# Access Compliance Report

## Public Rights-of-Way

Intersection ID: 44337	Main Street: SYCAMORE_CREEK_DR	Cross Street: E_ARROWWOOD_RD	Location: NE
ADA ID: 44C68C277A3A	Ramp Type: PerpDiag	Initial Pass/Fail: Fail	Overall Compliance: No
Severity Score: 21.25			
Codes/Mitigation Info/Possible Solution		Field Measurements/Component Compliance

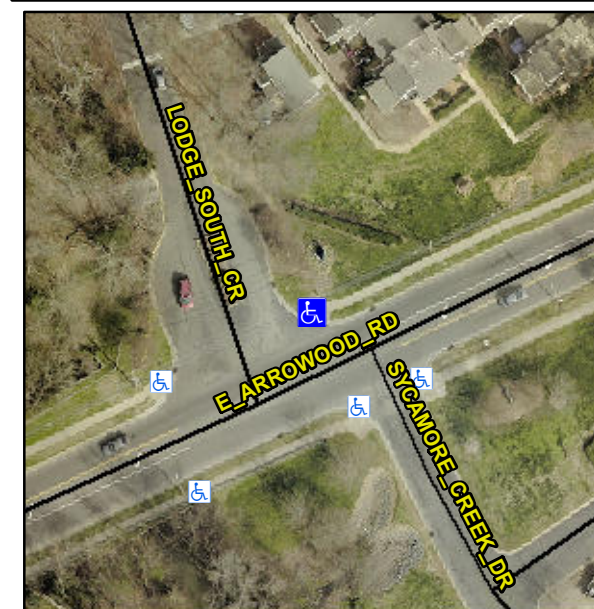
**Not Found, R304.5.1, R304.2.2**

Compliance	Description	Data	Compliance	Description	Data
N/A	Ramp Length (in)	60.0	No	Ramp Slope (%)	9.2
No	Ramp Width (in)	40.0	Yes	Ramp XSlope (%)	0.4
N/A	Flare Type LT	N/A	N/A	Flare Type RT	N/A
N/A	Flare Slope LT (%)	N/A	N/A	Flare Slope RT (%)	N/A
N/A	Flare Traversable LT?	N/A	N/A	Flare Traversable RT?	N/A
N/A	Landing Length (in)	N/A	N/A	DWS Provided?	N/A
N/A	Landing Width (in)	N/A	N/A	DWS Contrast?	N/A
N/A	Landing Slope (%)	N/A	N/A	DWS Length (in)	N/A
N/A	Landing X Slope (%)	N/A	N/A	DWS Full Width?	N/A
N/A	Landing Curb? (Y/N)	N/A	N/A	DWS Offset (in)	N/A
N/A	Shared Landing?	N/A			
N/A	Gutter Ponding?	N/A	N/A	Gutter Slope (%)	N/A
N/A	Gutter Lip Ht (in)	N/A	N/A	Gutter X Slope (%)	N/A
N/A	Painted X Walk1?	No	N/A	Painted X Walk2?	No
	X Walk 1 Direction	To SW		X Walk 2 Direction	To S
N/A	X Walk 1 Width (in)	N/A	N/A	X Walk 2 Width (in)	N/A
	X Walk 1 Slope (%)	0.6		X Walk 2 Slope (%)	5.1
	X Walk 1 X Slope (%)	0.7		X Walk 2 X Slope (%)	2.0

**Remove & Replace Curb Ramp With Two New Directional Ramps or Equivalent.**
